Access Compliance Report

Public Rights-of-Way

(Curb Ramps)

Intersection ID: 13893	Main Street: BUTTERNUT_CT	Cross Street: EUCLID_AV	Location: W
ADA ID: 25F9511DC9EA	Ramp Type: Directional1	Initial Pass/Fail: Fail	Overall Compliance: No
Codes/Mitigation Info/Possible Solution		Field Measurements/Component Compliance	
Severity Score: 43.75

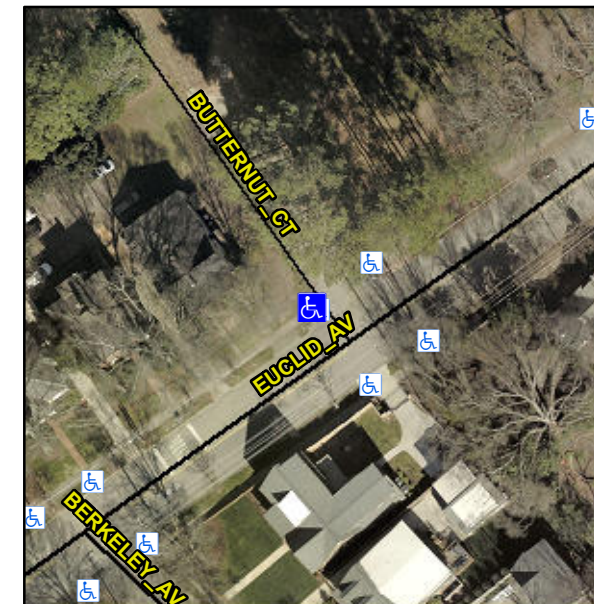
R304.5.1, R304.2.2

Compliance	Description	Data	Compliance	Description	Data
N/A	Ramp Length (in)	135.0	N/A	Grade Break?	N/A
No	Ramp Width (in)	32.0	N/A	Grade Break Slope (%)	0.0
No	Ramp Slope (%)	22.1	N/A	Grade Break XSlope (%)	0.0
Yes	Ramp XSlope (%)	3.4			
N/A	Flare Type LT	N/A	N/A	Flare Type RT	N/A
N/A	Flare Slope LT (%)	N/A	N/A	Flare Slope RT (%)	0.0
N/A	Flare Traversable LT?	N/A	N/A	Flare Traversable RT?	N/A
N/A	Landing Length (in)	0.0	N/A	DWS Provided?	N/A
N/A	Landing Width (in)	0.0	N/A	DWS Contrast?	N/A
N/A	Landing Slope (%)	0.0	N/A	DWS Length (in)	N/A
N/A	Landing X Slope (%)	0.0	N/A	DWS Full Width?	N/A
N/A	Landing Curb? (Y/N)	N/A	N/A	DWS Offset LT (in)	N/A
N/A	Shared Landing?	N/A	N/A	DWS Offset RT (in)	N/A
N/A	Gutter Ponding?	0.0	N/A	Gutter Slope (%)	N/A
N/A	Gutter Lip Ht (in)	0.0	N/A	Gutter X Slope (%)	N/A
N/A	Painted X Walk1?	No		Road Slope (%)	6.1
	X Walk 1 Direction	To SE		Road X Slope (%)	5.1
	X Walk 1 Width (in)	N/A		Clear Space?	N/A

X Walk 1 Slope (%)	6.1	N/A	Clear Space to XWalk (in)	N/A
	X Walk 1 X Slope (%)	5.1	N/A	Storm Grate/Utility Hazard?	N/A
N/A	Ramp inside XWalk1?	N/A		Storm Grate/Utility Type	
N/A	Any Obstructions?	N/A			N/A
	Obstruction Type		Yes	Surface Condition? (G/P)	Good
			N/A	Curb Slope (%)	19.1

Remove & Replace Entire Ramp.
